### NEW DOOR GASKET TO AVOID THE SWITCH OFF OR START PROBLEMS IN “MW” FUNCTIONS

The following instructions for the Service regarding exchange of Compact Microwave door gasket, valid for Compact ovens (models listed below) with new plastic inner door cover starting with serial No. **9 09 30360** until serial No **2 01 30083**.

Fig. 1

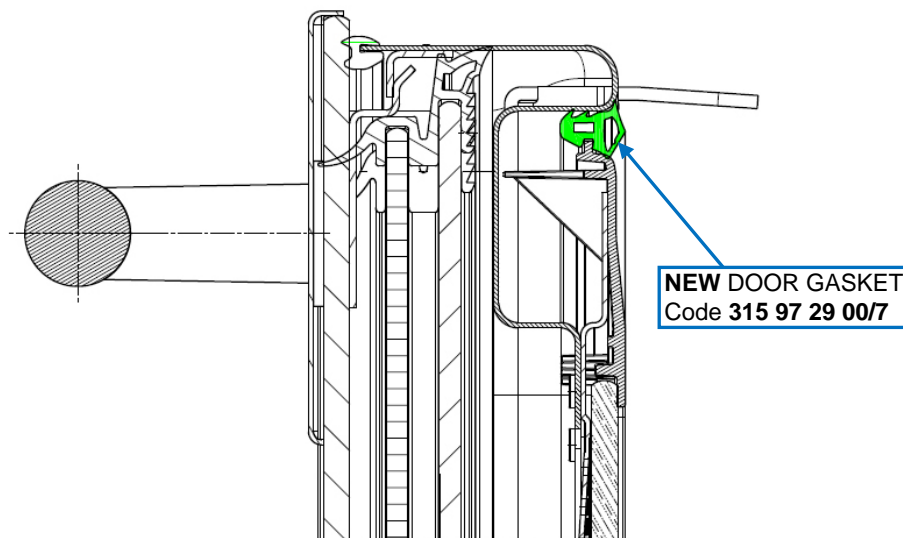
- Problem:** During microwave operation, the appliance switches off or can't be started.
- Reason:** The micro switches behind the front frame are not switched steadily
- Cause:**
- a) Door gasket too high (dimensional)
  - b) Adjustment of door switch not aligned
- Line of action:**
- 1. Move door switch completely into direction to the door and fix it with the new T25 M4x8 screw (Spare Code **315 96 21 00/6**).
  - 2. Insert new door gasket (Spare Code **315 97 29 00/7**).
  - 3. When performing the functional test, the appliance must remain in operation until the gap between door and front frame exceeds 0.5mm.
- Built in situation:** Cross section through the door (door handle on the left) the rectangular gap is filled with the plastic door cover both spikes are pressed against the enamelled door frame.

**Factory :** New door gasket in use from serial No **201 30084**
